DEVELOPMENT REVIEW COMMITTEE (DRC) COMMENT REPORT

PROJECT NAME: Flagler II

CASE NUMBER: R19026

REQUEST: Site Plan Level II Review: Change of Use from Warehouse to Retail, Office and Restaurant and Associated Parking Reduction in Northwest Regional Activity Center

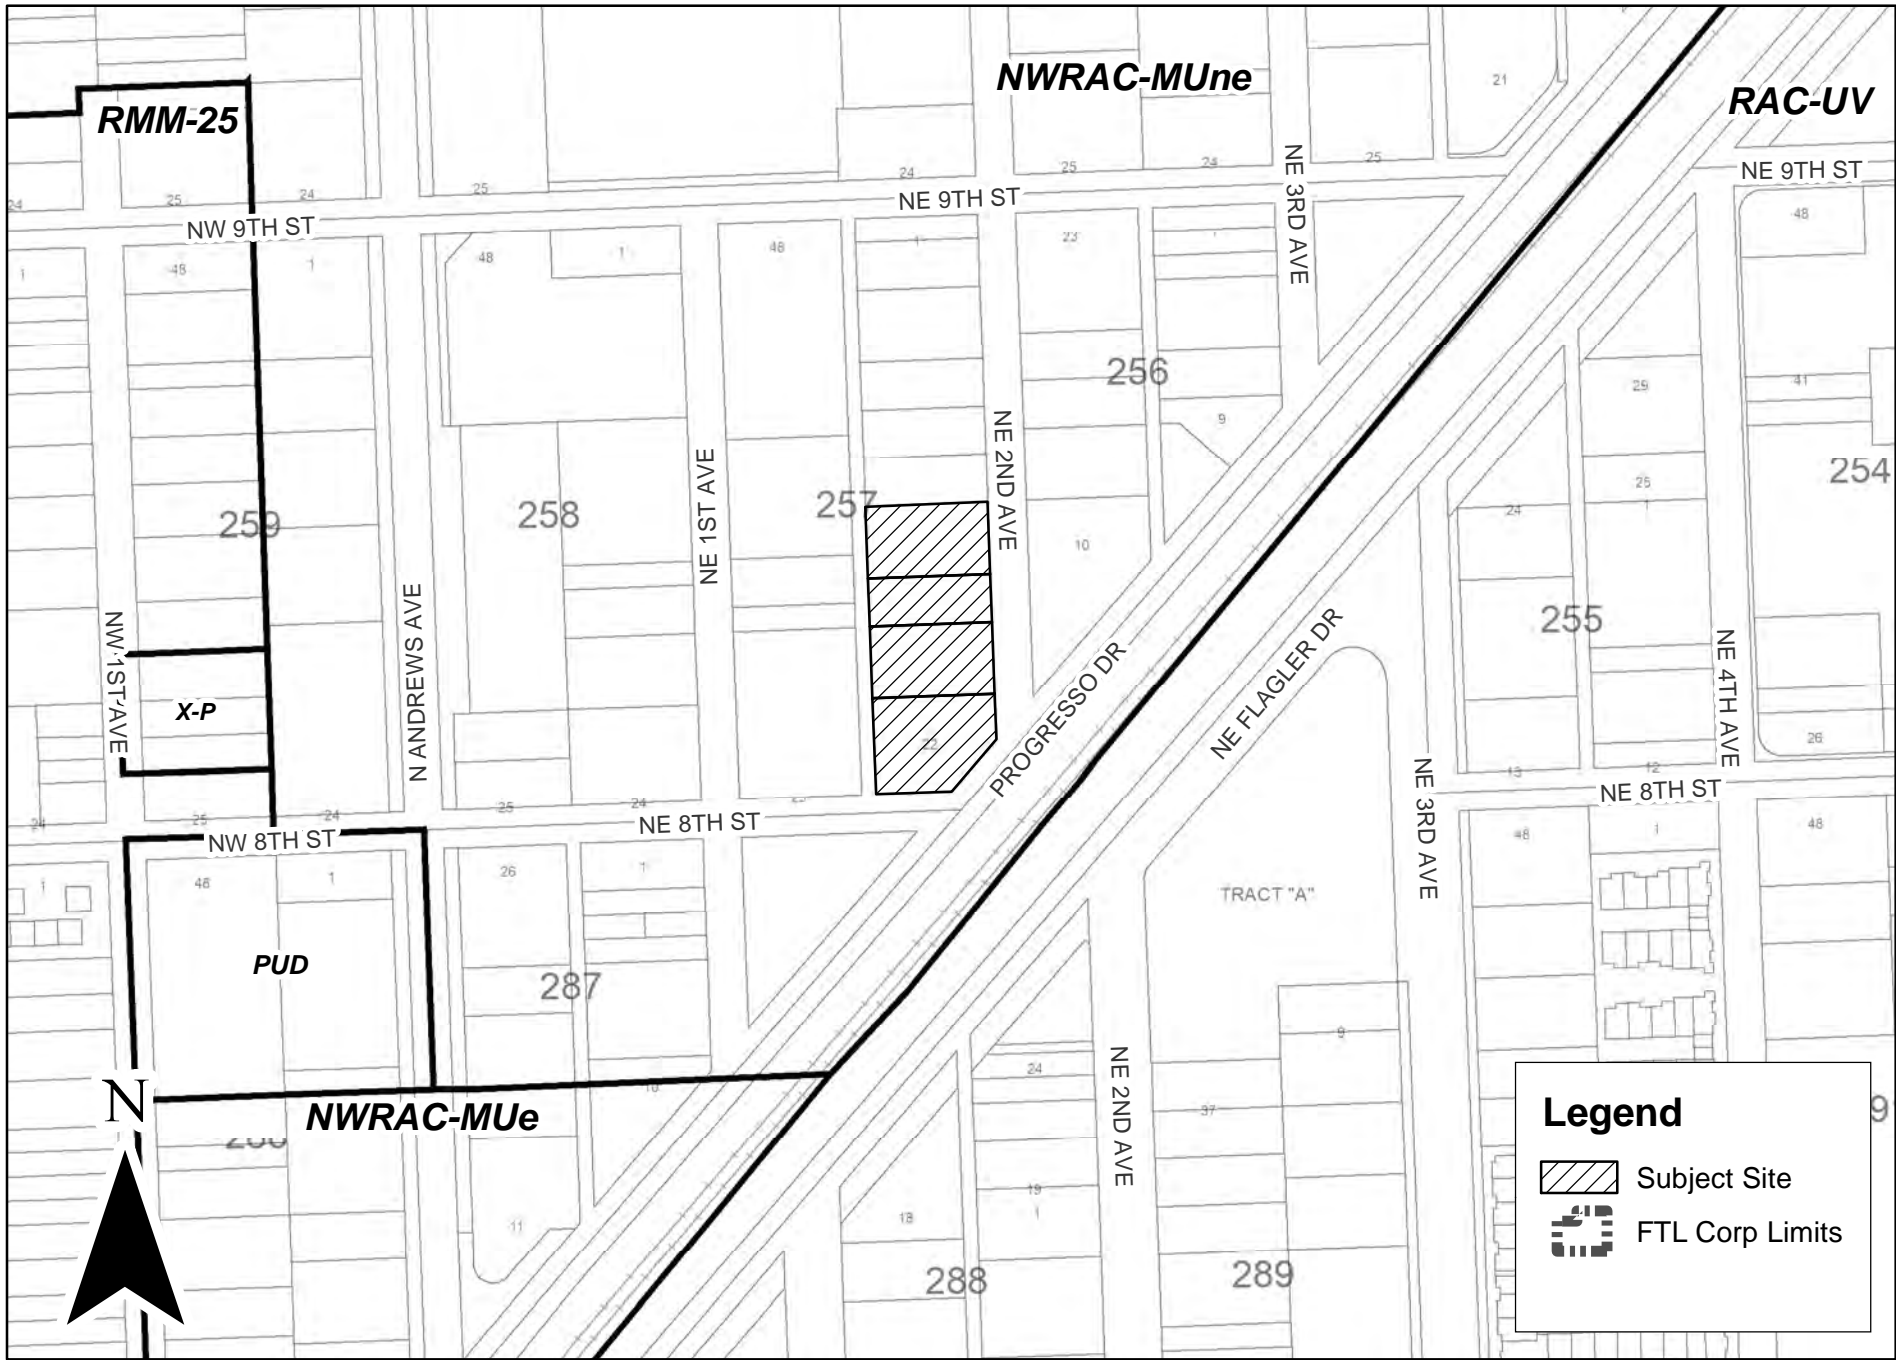
- 7) For closer consistency with the NWRAC Illustrations of Design Standards, consider the following site plan changes:
 - a. Shift parallel parking spaces on N.E. 2nd Avenue, within the City right-of-way, along the property line to align with the positioning and parking stall width of the approved plans at 835 and 837 N.E. 2nd Avenue. Approved plans for the proposed streetscape improvements related to 835 and 837 NW 2nd Avenue have been provided for reference - Case Number (A17062).

- b. Provide a 5' sidewalk along the northeast corner of the building, running east to west to connect the existing sidewalk walk along N.E. 2nd Avenue and the approved 5' sidewalk proposed at 835 and 837 N.E. 2nd Avenue. Additionally, widen portions of the existing sidewalk along the perimeter of the building to make all sidewalks 5' wide; provide additional landscaping between the sidewalk and the relocated parking stalls; and, consider adding pedestrian friendly features, such as, but not limited to, benches and bicycle parking.

Or

Provide a 5' sidewalk along N.E. 2nd Avenue, abutting the City right-of-way, to align with the approved 5' sidewalk proposed at 835 and 837 N.E. 2nd Avenue and connect with the existing sidewalk along the southeast corner of the building. Provide additional landscaping and pedestrian friendly features,

such as, but not limited to, benches and bicycle parking between the sidewalk and building. Provide additional sidewalks as needed to connect the building entrances to the sidewalk.
